United States Golf Association
Golf House
PO Box 708
Far Hills, NJ 07931

July 27, 2009
Notice to Manufacturers

Groove Geometry

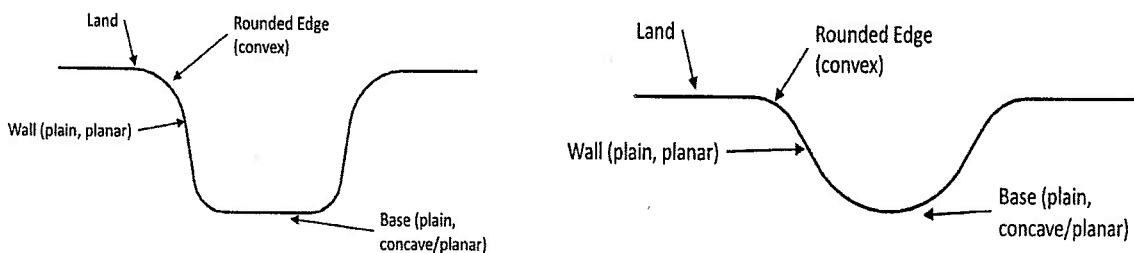
The groove starts where there is a significant departure from the plane of the face ("land") and this is joined to the wall of the groove via the edge. The wall continues to the base of the groove.

The edge must be substantially in the form of a round (having an effective radius of not less than 0.010", as determined by the two circles method, and not greater than 0.020"), which comprises an arc to which the groove wall and the land are tangential. As such, the ends of the "round" coincide with the ends of the edge - one end marking the joint to the land and one end marking the start of the groove wall. To further clarify, this means that groove edges must be a convex curve and must not include serrations, gear teeth or other similar features.

The USGA reserves the right to define the extent of the groove edge. Edge configurations, including (but not limited to) chamfers, fillets, notches, etc. do not conform to the Rules since they are not in the form of a round. An allowance may be made for edge regions not strictly fulfilling this requirement as a result of production variations, but any such variations must be minimal and not part of the club's intended design.

- (i) The wall of the groove must be substantially “plain” and “planar”. This would disallow features such as bends, indentations in or protrusions from the wall.
- (ii) The base of the groove must also be substantially “plain” and join the two opposing walls of the groove using a concave shape or a plane.
